PREVOST

WARRANTY BULLETIN

WB13-32B

DATE :	JUNE 2013	SECTION :	04 - Exhaust
EXPIRATION:	JUNE 2015		
SUBJECT :	NOX SENSOR REPLACEMENT & SOFTWARE UPDATE

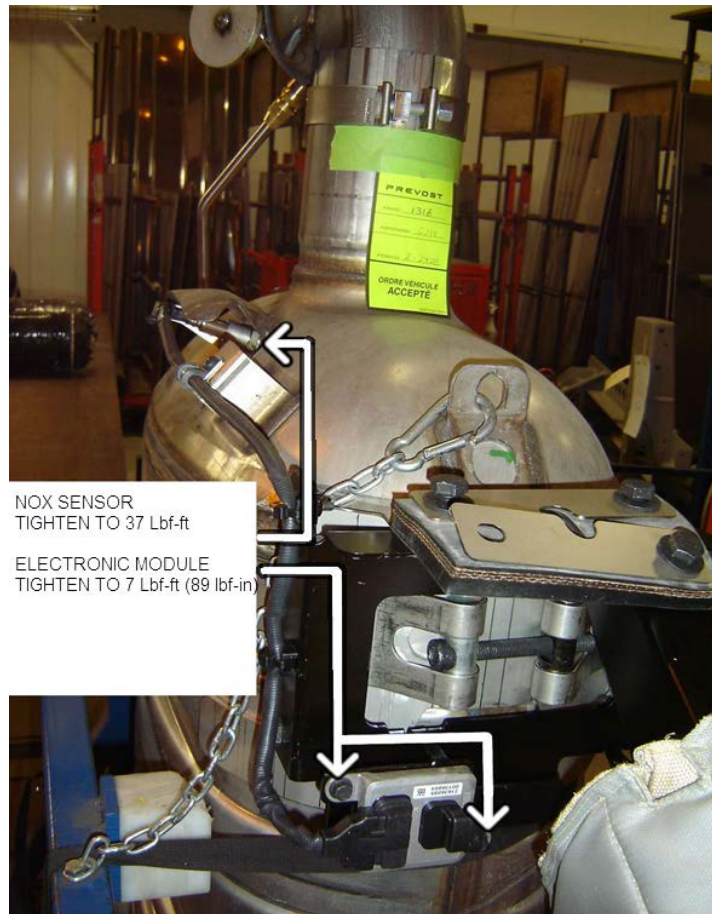
3. Replace NOx sensor 21636088 by 22014032
4. Tighten sensor to 37 lbf-ft
5. Tighten mounting bolts to 7 lbf-ft (89 lbf-in)

NOX SENSOR
TIGHTEN TO 37 Lbf-ft

ELECTRONIC MODULE
TIGHTEN TO 7 Lbf-ft (89 lbf-in)
